**Subject: Annual Inspection Report
Headland Municipal Airport**

ANNUAL INSPECTION REPORT

HEADLAND MUNICIPAL AIRPORT

Photo #7 – NPI Markings Rwy 27

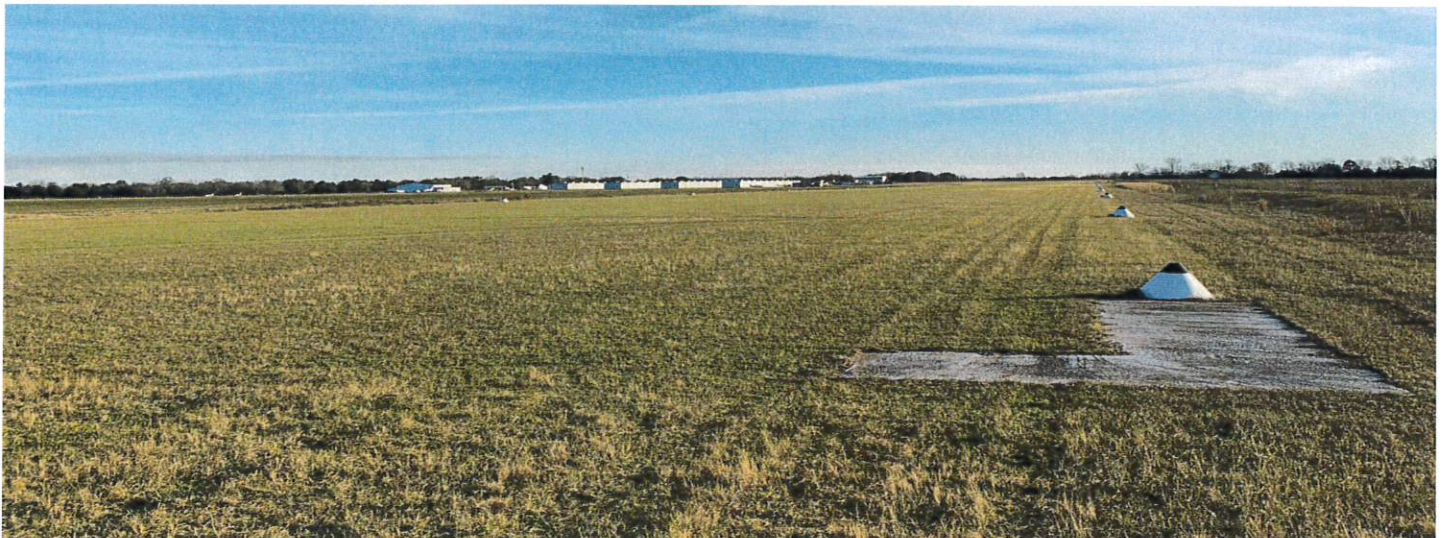
- The non-precision runway markings for runway 9/27 are in POOR condition; beginning to fade due to algae growth and weathering (See Photo #7).
- The turf markings for runway 17/35 are in GOOD condition. The runway threshold markers on Runway 17/35 are faded (See Photo #8).

- Clean Runway 9/27 markings or replace markings in accordance with FAA AC 150/5340-1M if they cannot be cleaned.
- Repaint Runway 17/35 threshold markers.
